Architectural Design Statement

For KPH Construction at Killowen, Kenmare, Co.Kerry

5.0 - Response to 32B Consultation Meeting

The following chapter has been prepared in response to the feedback received during the 32B consultation and the subsequent minutes issued by Kerry County Council. It outlines the architectural response to the relevant comments and the resulting refinements to the proposal.

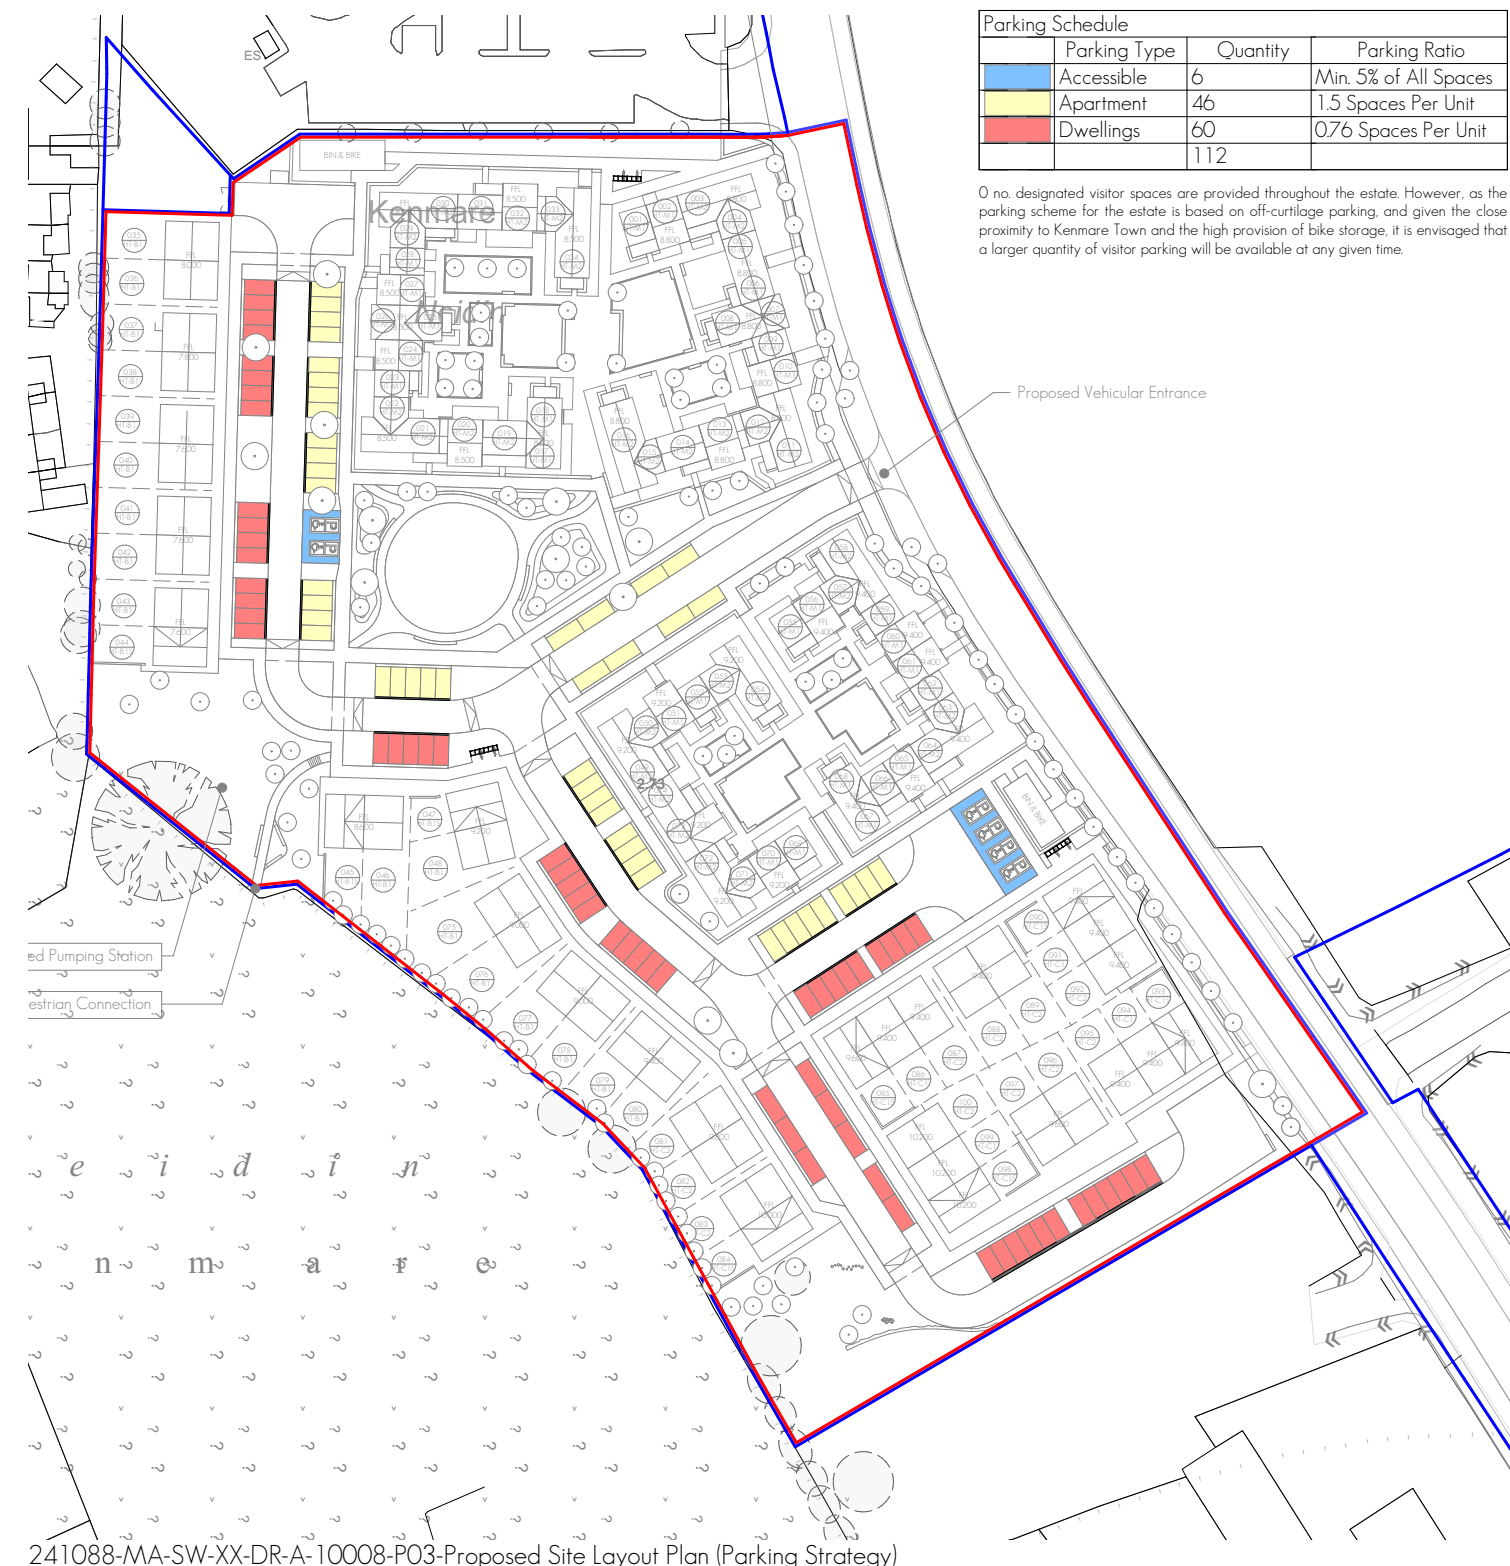
Car parking spaces for disabled should be distributed throughout the estate, not assigned to one area and relocated closer to apartments rather than the houses.

The proposed accessible parking spaces have been carefully positioned to maximise accessibility while responding appropriately to the site layout and the operational requirements of the internal road network. The accessible parking bays are grouped in close proximity to the proposed apartment buildings, providing convenient and direct access for residents and visitors with reduced mobility.

To the northern part of the site, the accessible parking spaces are strategically located to serve both the apartment units and the proposed public open space, ensuring convenient access to the principal amenities within the development. Safe and accessible pedestrian routes are provided from these spaces via Part M-compliant footpaths, incorporating dropped (dished) kerbs, level crossing points, and appropriate gradients to facilitate ease of movement throughout the site.

The proposed arrangement is considered to represent the most efficient and practical use of the available space, while delivering a high standard of accessibility and ensuring that the accessible parking provision effectively serves the key destinations within the development.
